REPORT AMENDED BY STAFF 8-27-87
CITY PLANNING COMMISSION

- APPLICATION:**
- A. Negative Declaration
 - B. Special Permit to develop a drive-through restaurant in Valley Hi Centrum PUD
 - C. Variance to waive the required six foot high solid masonry wall
 - D. Schematic Plan Amendment to allow access off of Valley Hi Drive

PROPOSAL: The applicant is requesting the necessary entitlements to construct a fast food restaurant with a drive-up window

WENDY'S
VALLEY - HI DRIVE
SACRAMENTO, CALIFORNIA

BUILDING FLOOR PLAN

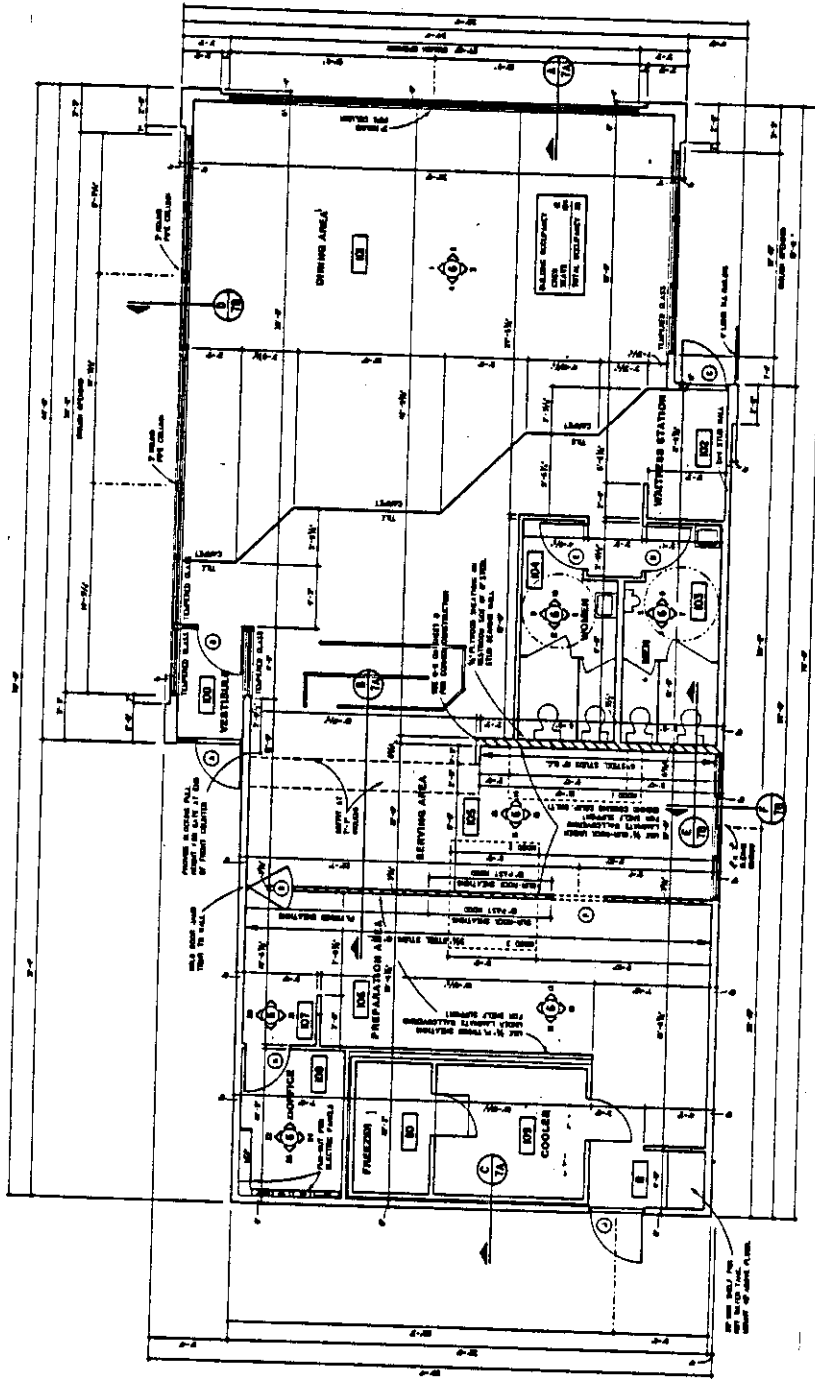
Staff has reviewed the proposed building elevations and recommends a design change in the proposed roof to a gable roof with overhang. This revision would be more compatible with the adjacent new apartment complex and medical building location on the corner of Valley Hi Drive and Bamford Street.

The east (front) elevation shows a Wendy's sign. The total vertical sign height proposed is 36 inches exceeding the allowable 28 inch vertical sign height. Staff recommends this sign be revised to comply with the sign regulations in the PUD guidelines. A sign program shall be submitted to the Planning Director for review and approval prior to the issuance of a sign permit.

1. Landscaped and irrigation plans shall be submitted for review and approval by the Planning Director prior to the issuance of a building permit.
2. The applicant shall comply with the Valley Hi Centrum PUD Guidelines (Exhibit A).
3. Revised building elevations shall be submitted to staff for review and approval prior to the issuance of a building permit. These revised elevations shall include a gable roof with an overhang.
4. A sign program shall be submitted to staff for review and approval prior to the issuance of sign permits.
5. An eight foot high decorative masonry wall shall be located on the west portion

SCHMATIC PLAN

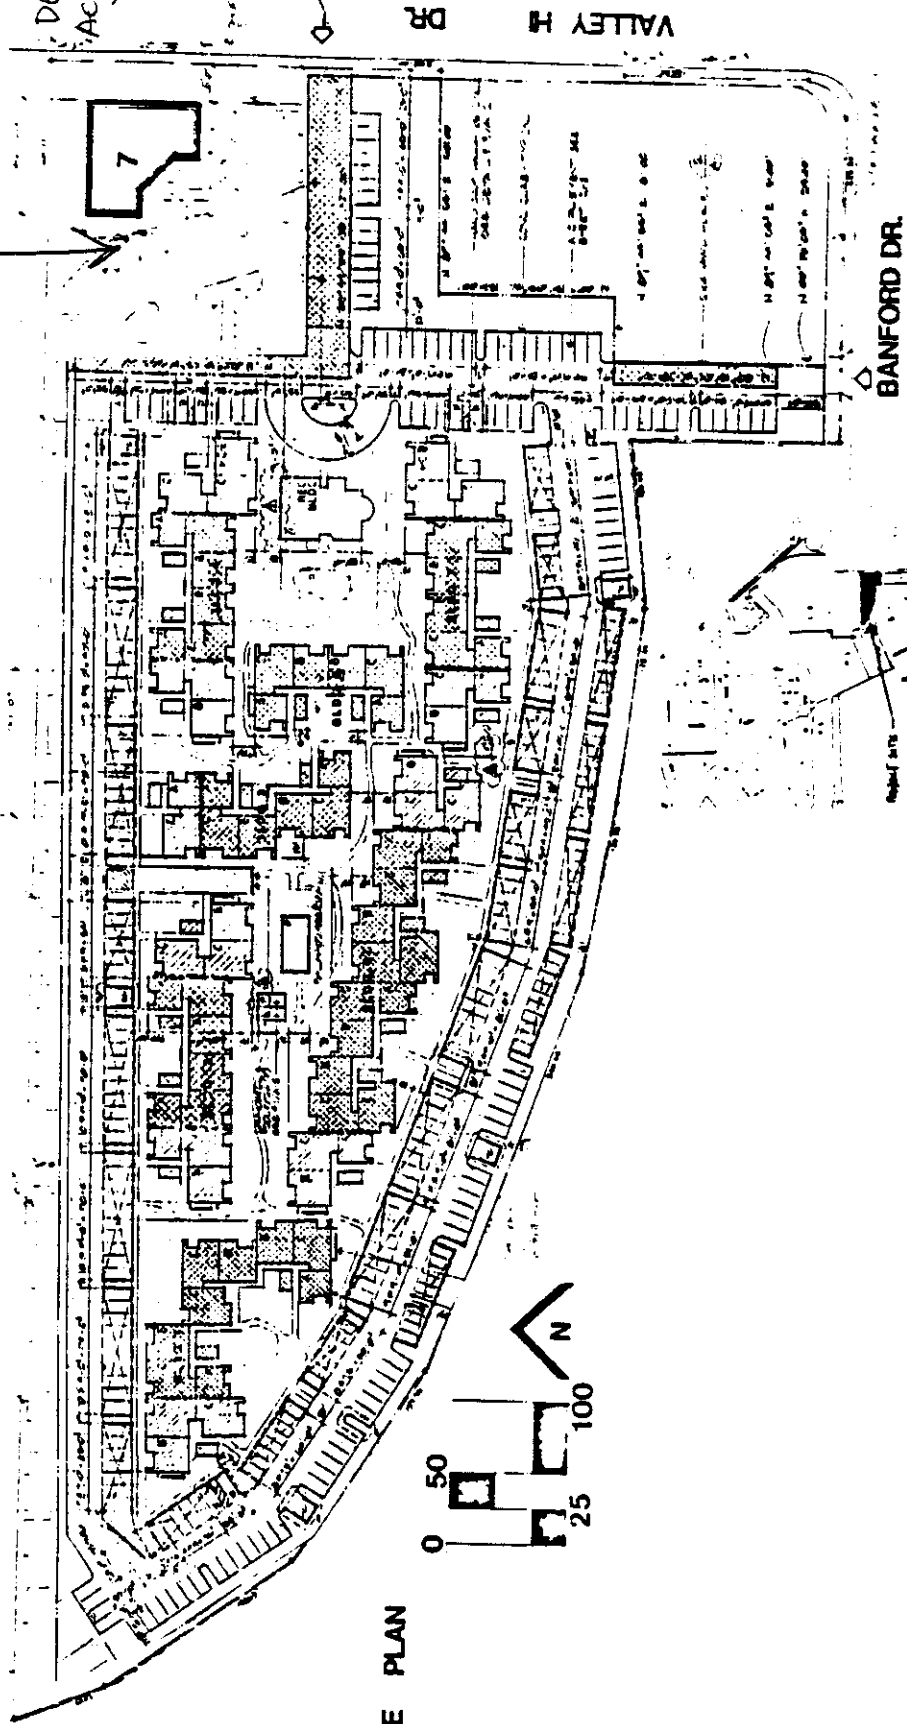
A Schematic Plan Amendment is also requested to allow an access from Valley Hi Drive not shown on the Valley Hi Centrum PUD Schematic Plan (see Schematic Plan and site plan). Traffic Engineering has evaluated this request and has no objection to providing another access off of Valley Hi Drive to the subject site as shown on the site plan. Staff concurs with Traffic Engineering and recommends approval of the proposed Schematic Plan Amendment.

- A. Ratify the Negative Declaration;
- B. Approval of the Special Permit subject to conditions and based upon findings of fact which follow;
- C. Approval of the Variance to waive the required six foot high masonry wall based upon findings of fact which follow;
- D. Amend the Schematic Plan to allow access off Valley Hi Drive.
